ADDENDUM NO.: 2  
 DATE OF CMR ADDENDUM: 01.22.2013

<b>Project Name:</b>	<b>Southern Connecticut State University Buley Library Renovation</b>
<b>Project Location:</b>	<b>New Haven, CT</b>
<b>Project Description:</b>	<b>Core &amp; Shell &amp; Fit-Out</b>
<b>Project Construction Budget:</b>	<b>20.7 Million</b>
<b>CT DCS Project Number:</b>	<b>BI-RS-225B CMR</b>

**ADDENDUM NO. 2**

**B-SKM-04**

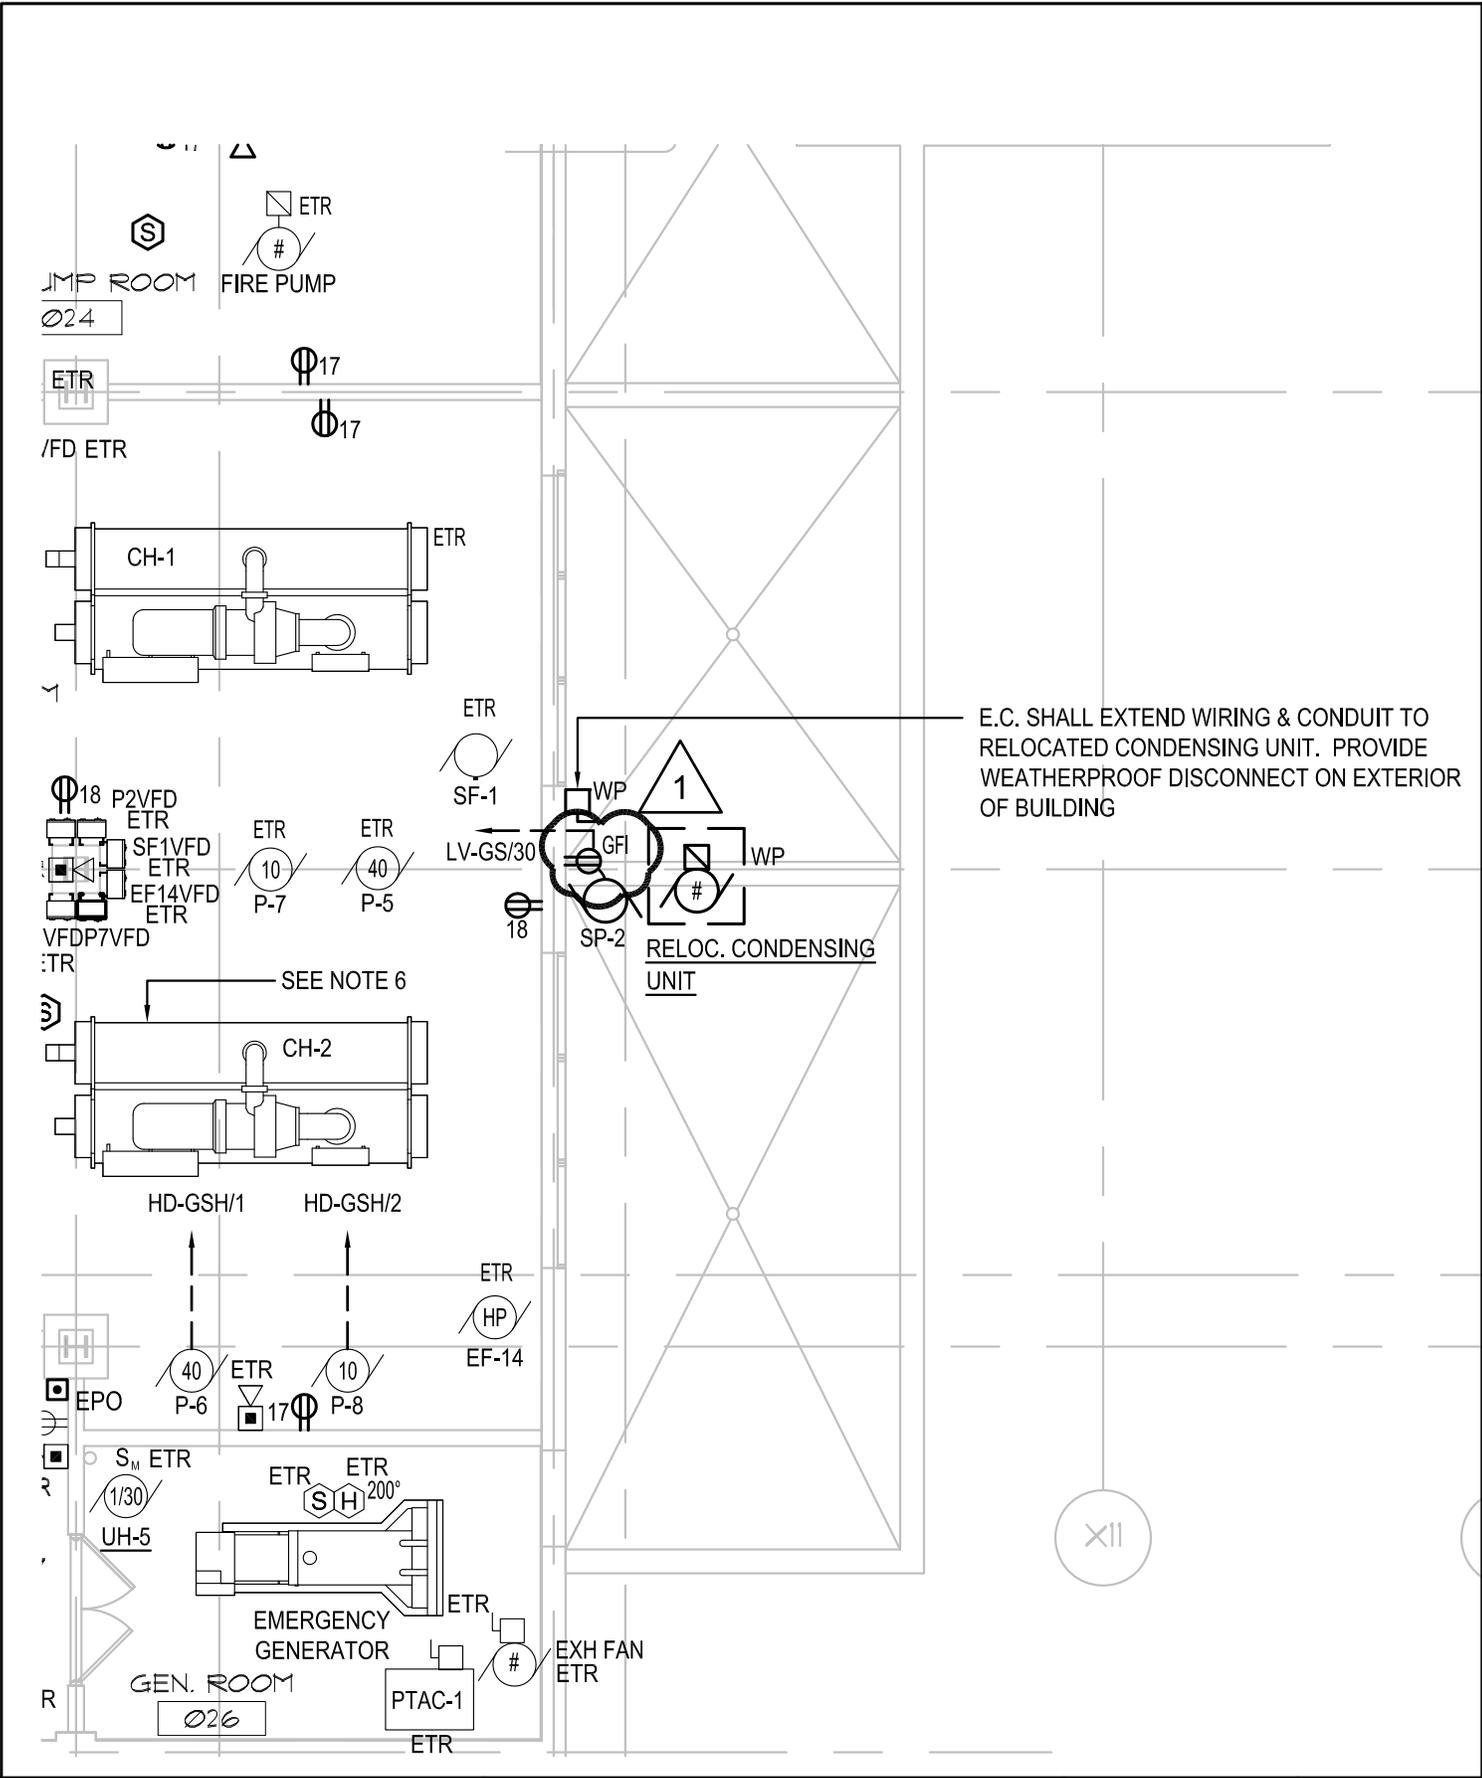
- k. B-SKM-04 Cooling Tower Overflow Drain
  - l. B-SKM-05 Cooling Tower Schedule Revisions
  - m. B-SKE-01 Added GFI Outlet Near Reloc. Condensing Units Basement
